Observations on the SBA Application for a Special Permit to Install a Wireless Facility and Tower at 5 Craig Road, Acton, Massachusetts

September 13, 2013

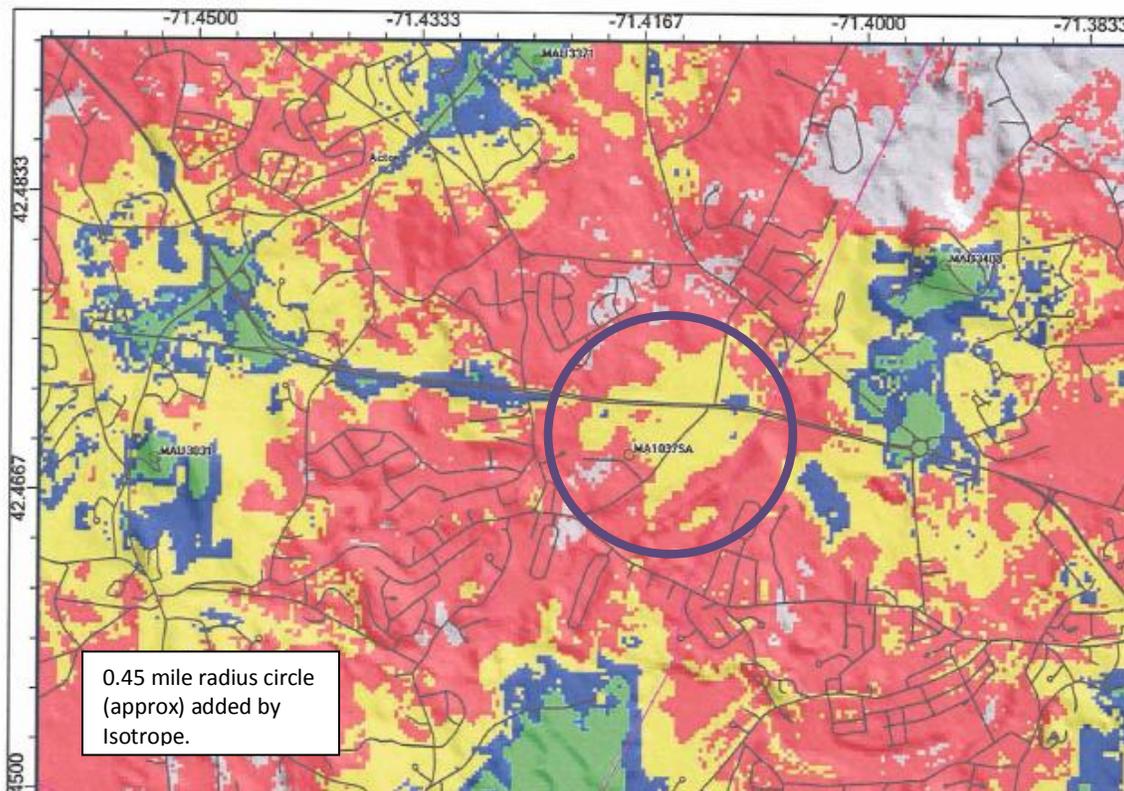
- Primary applicant SBA is not a wireless service provider and relies on prospective tenant AT&T to show whether there is a gap in service. AT&T provided two computer-estimated coverage maps (Tab 4) – one showing projected existing coverage (“Existing Coverage Map”) and one showing projected existing-plus-proposed coverage (“Proposed Coverage”). Our initial impressions are:

- It is not indicated whether the maps show coverage of 850 MHz Cellular, 1950 MHz PCS (or AWS), or 700 MHz service.
 - Existing coverage from the Annursnac Hill facility in Concord (MAU3403) appears to be remarkably dismal considering the significant advantage over the local terrain that the hilltop offers. Our first-approximation analysis on our computer suggests there is more coverage in the direction of the proposed facility than the map shows. We suggest that AT&T look for a possible data entry error in the setups of this site

- Coverage analysis needs additional information: Possible flaws in existing coverage analysis; if Isotrope second-opinion plots are desired, obtain the necessary data from AT&T; obtain analysis of coverage from lesser height (e.g. 80 feet) and a rationale as to why this or any lesser height is insufficient for AT&T.

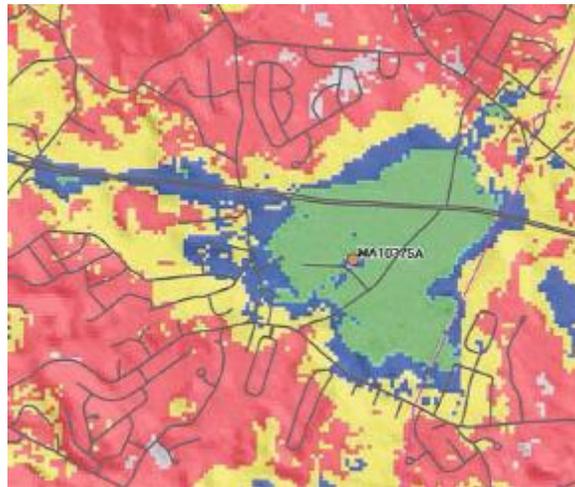
- Existing coverage from the Great Hill facility (MAU3031) also appears to be remarkably limited, considering the commanding elevation of that facility. This further reinforces the benefit of obtaining more specific information about the facilities' characteristics for us to model, and for AT&T to verify the accuracy of their data entry in their computer.
- The Site Acquisition Agent testifies that AT&T has a "significant gap" in a radius of "about .45 miles" centered south of RT 2 on School Street, near Craig Road.
- Counterintuitively, the middle of the purported gap has a higher existing signal level (according to the AT&T map) than its surroundings. See the circle we placed on the map segment below.
-

This is the 0.45 mile radius described by the applicant. Note how it encircles the yellow area of coverage, which is a stronger signal level class than the surrounding orange/red areas. (Note that while we rely on this map for this discussion, we do not abandon our concern, above, that there are other flaws in the coverage depicted.)
